RE: Round 3 Technical Review, Brook Mine Coal Mine Permit Application, TFN 6 2/025

TO: File, Brook Mine Coal Mine Permit Application, TFN 6 2/025

RE: Brook Mine application review of Round 2 Comments and Responses covering Adjudication, Land Use, History, Climatology, Topography, Geology, Overburden Assessment, Hydrology, Alluvial Valley Floors, Mine Plan, and Reclamation Plan

SUBJECT: Third Round Comments on Brook Mine Permit Application (TFN 6 2/025)

Map showing possible discrepancy in location of station SM578512-SW-1 on Slater Creek.

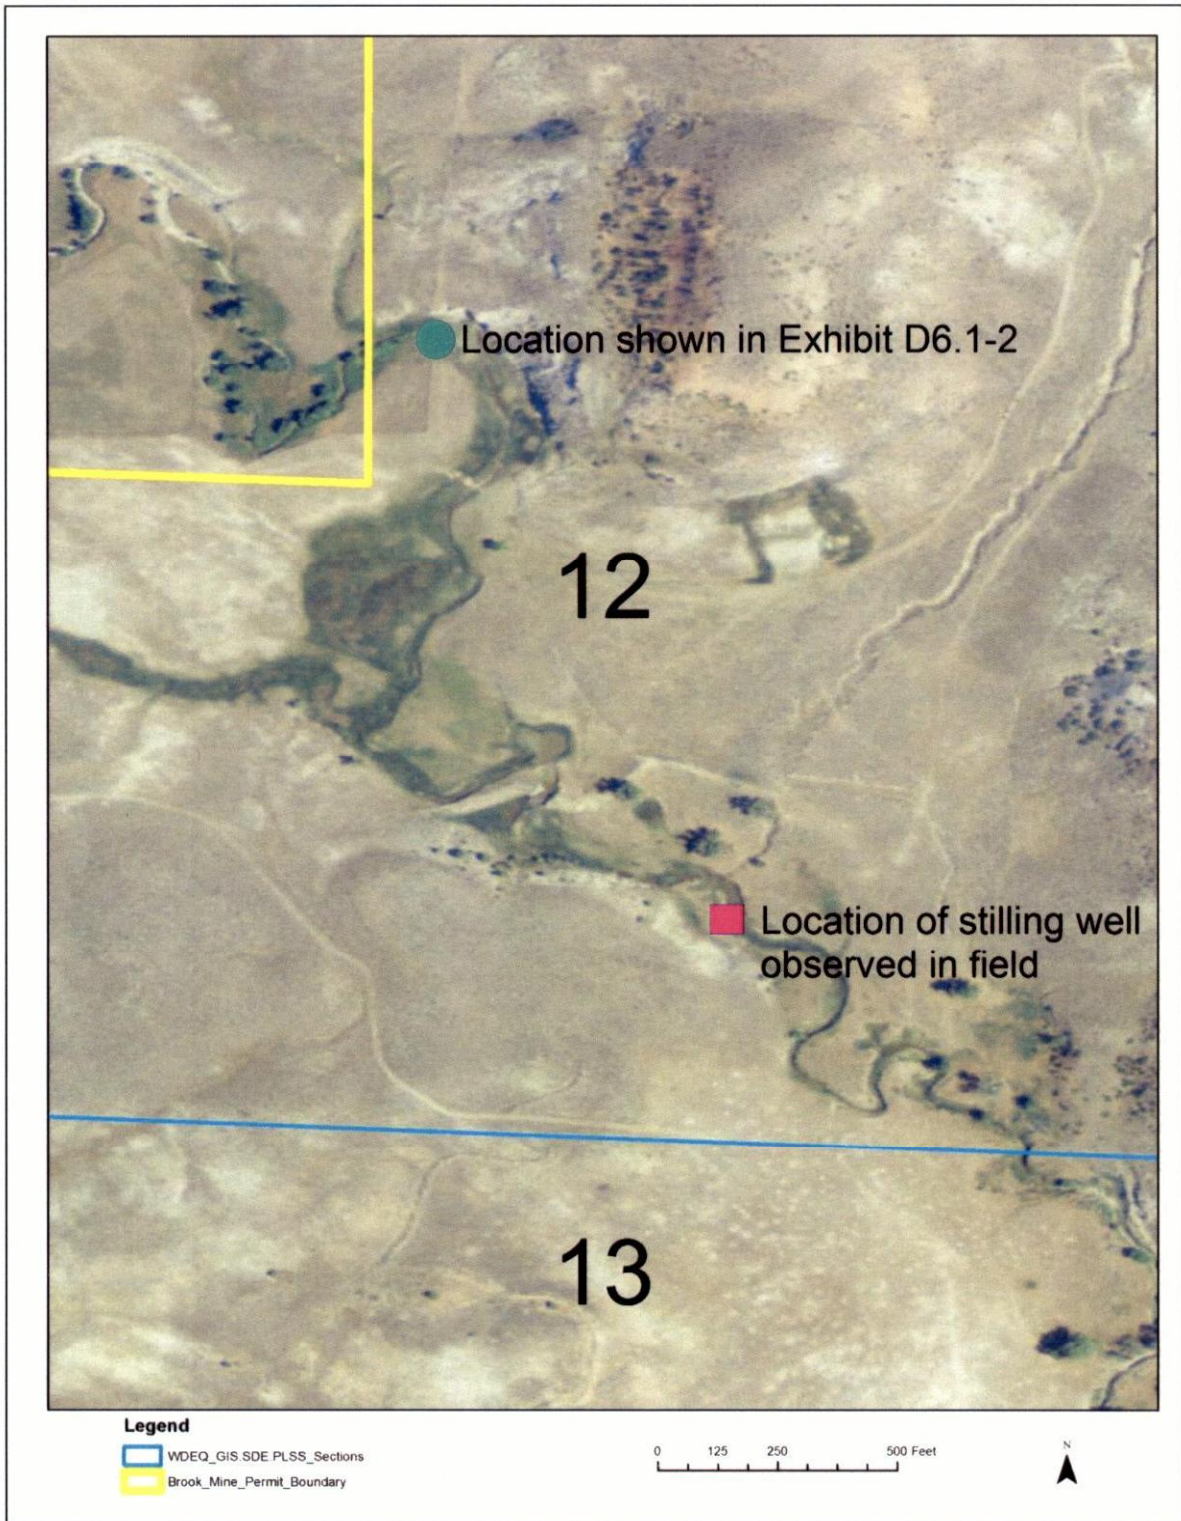
Comment MK 35. Response not accepted. Although the coordinates were included in Table D6.1-11 as requested, the location appears incorrect for the upstream monitoring station on Slater Creek (SM578512-SW-1). During the AVF reconnaissance site visit to Slater Creek on September 24, 2015, station SM578512-SW-1 was observed approximately 1,800 feet downstream from where it is currently shown in Exhibit D6.1-2. Please see the attached map and photo below. Please also note that the location observed in the field matches what is shown in Addendum D6-5 Figure D6-2. Please provide the correct coordinates and location for station SM578512-SW-1 in Table D6.1-11 and Exhibit D6.1-2. Please also update the coordinates in

Table MP.7-1 and the appropriate permit application Exhibits (Exhibit D6.1-2, Exhibit MP.7-1, Exhibit RP.8-5) to show the correct location of the station. (MDK)

Stilling well on right bank of Slater Creek, observed during September 23, 2015 site visit. Site was believed to be station SM578512-SW-1. Approximate location of this site is shown in the map below.

Map showing possible discrepancy in location of station SM578512-SW-1 on Slater Creek.

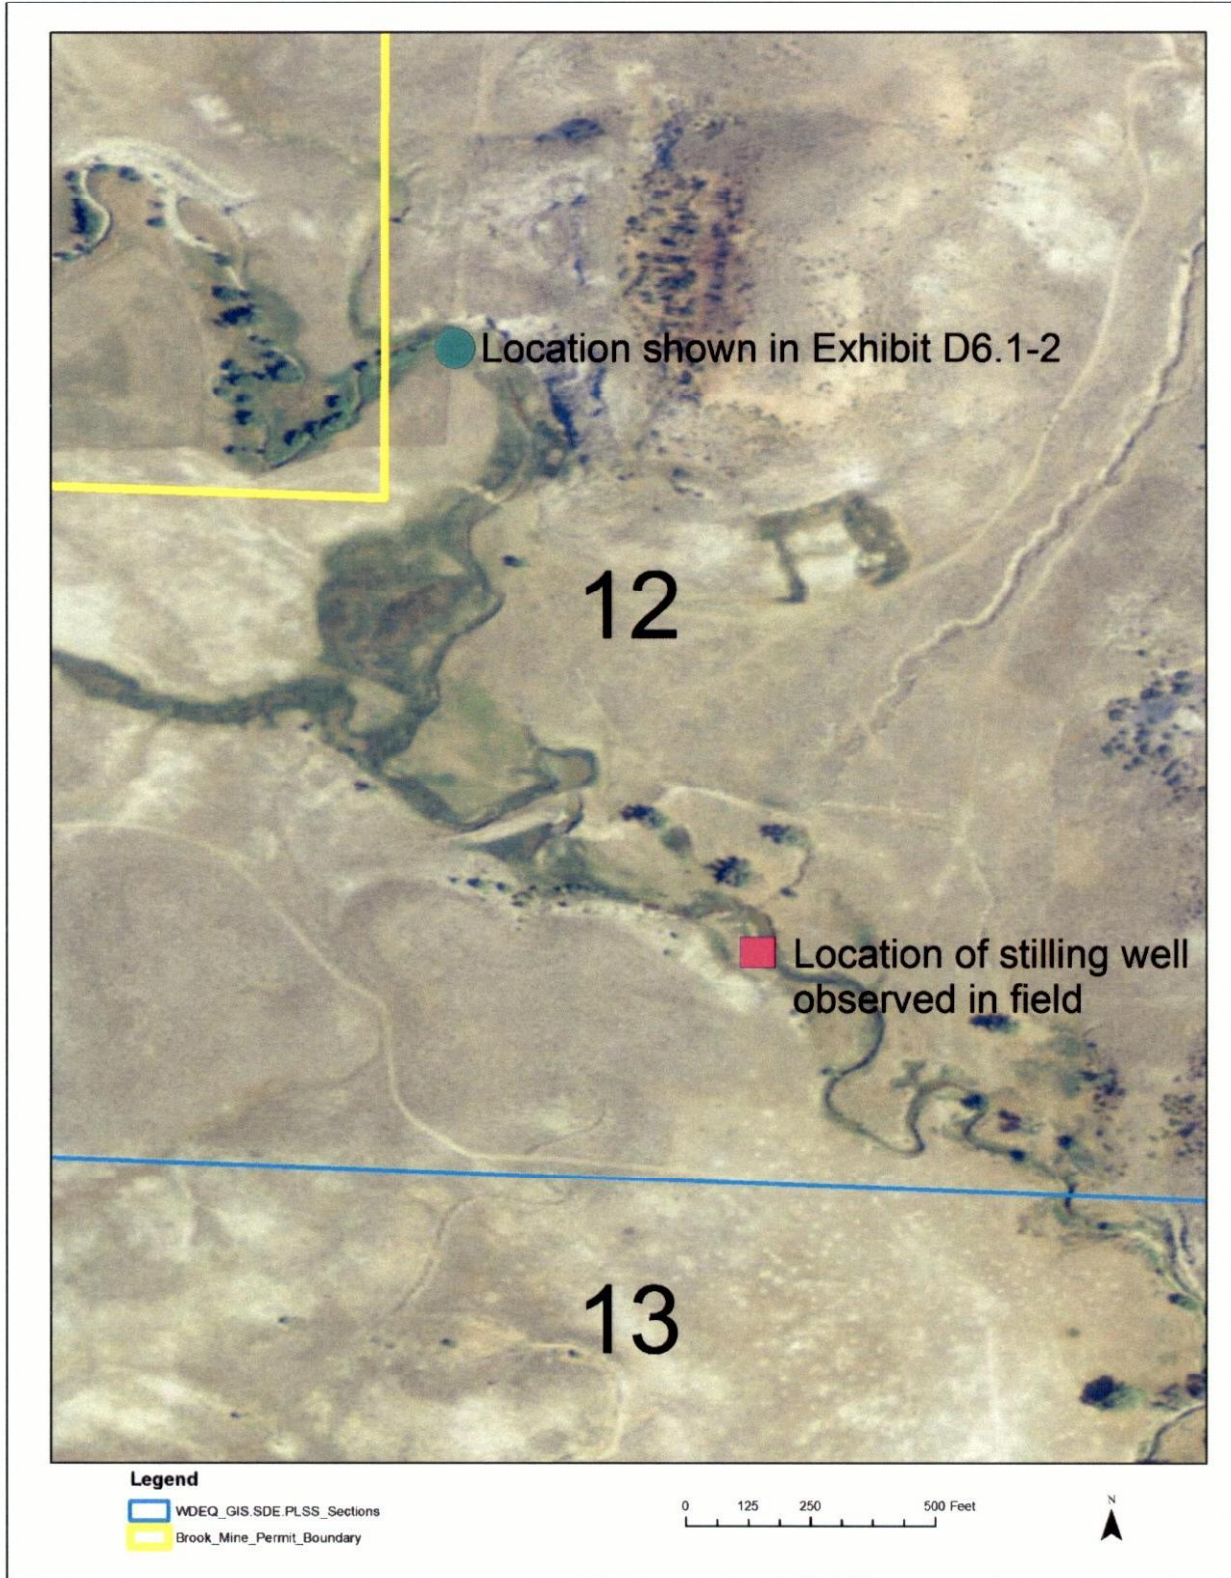
Table MP.7-1 and the appropriate permit application Exhibits (Exhibit D6.1-2, Exhibit MP.7-1, Exhibit RP.8-5) to show the correct location of the station. (MDK)

Stilling well on right bank of Slater Creek, observed during September 23, 2015 site visit. Site was believed to be station SM578512-SW-1. Approximate location of this site is shown in the map below.
